Bulletin No.: PIT5931A  
Published date: 09/6/2022

### PIT5931A Clunk or Rattle from Front of Vehicle on Bumps or Turns

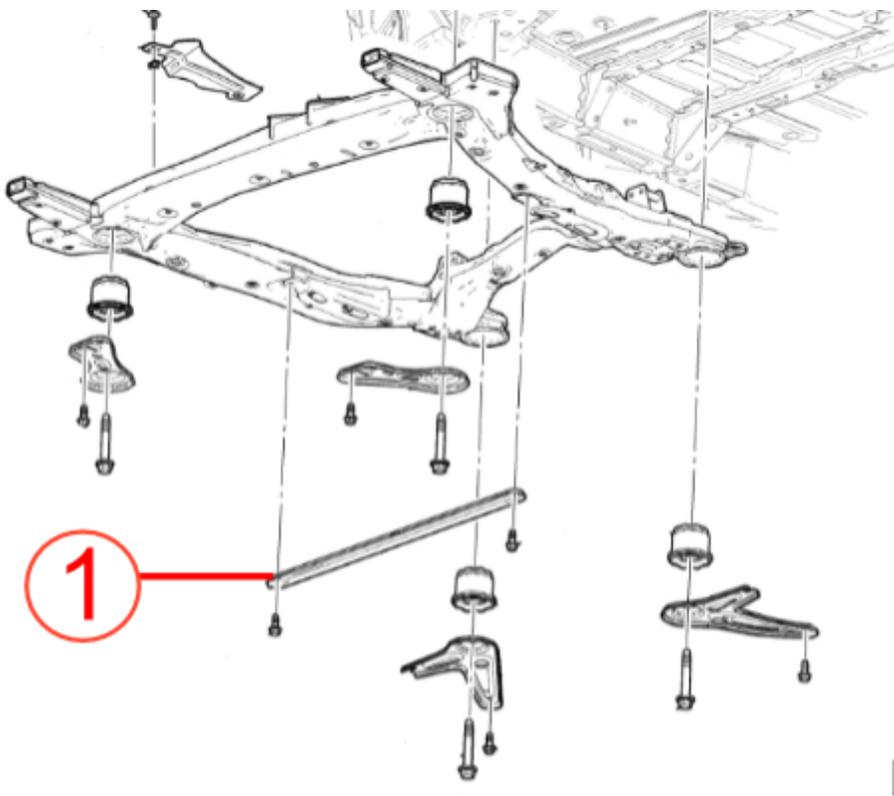
**The cradle brace may be loose, mispositioned or improperly torqued.**

**The cradle brace is a flat bar that attaches across the cradle with a bolt on each end.**

**See # 1 in illustration below.**

**Remove the cradle brace and drive the vehicle under the conditions that will duplicate the noise.**

**Note: Simply torquing the brace may not resolve the concern. It needs to be removed, reinstalled and torqued.**

**If the noise is gone with the brace removed, reinstall the brace and torque to specification.**
